# Cascadia Chassis Side Fairing Lower Air Deflector Retention

# 31-32

**Freightliner  
Service Bulletin**

**Description of Revisions:** *This bulletin replaces the version dated May 2013. The procedure has been revised to use production retaining clips.*

**Fig. 2, Air Deflector and Fairing Installation**

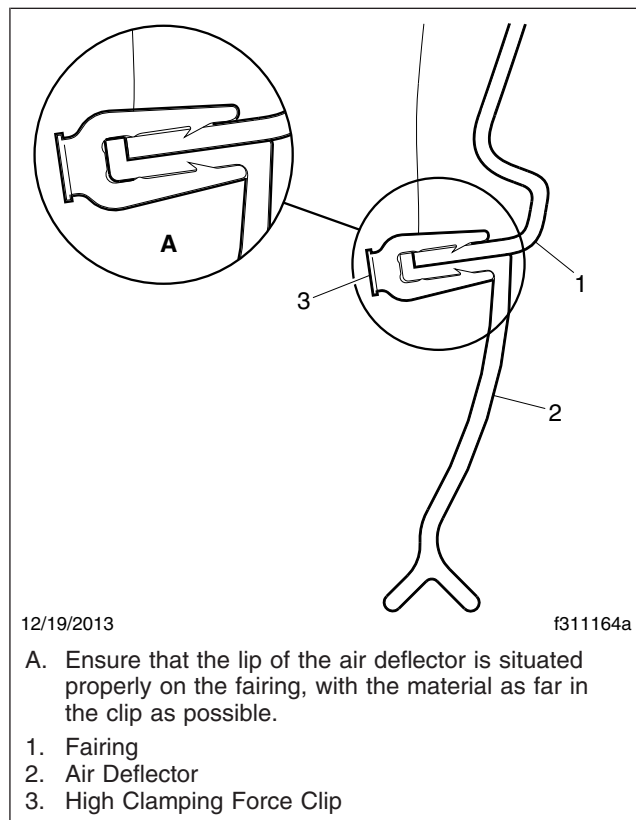
3. Ensure that the lip of the air deflector is situated properly on the fairing, with the material as far in the clip as possible. See [Fig. 2](#).
4. Working one clip location at a time, pry each existing C-clip off with a flathead screwdriver and replace it with a new retaining clip in the same location. Tap the new clip into place with a rubber mallet. Repeat this task for every clip.

**NOTE:** Make sure to use the same location and spacing as the existing clips. If clips are missing, the clip spacing for particular fairing configurations are shown in the installation drawing D22-69272 via EZWiring in PartsPro.
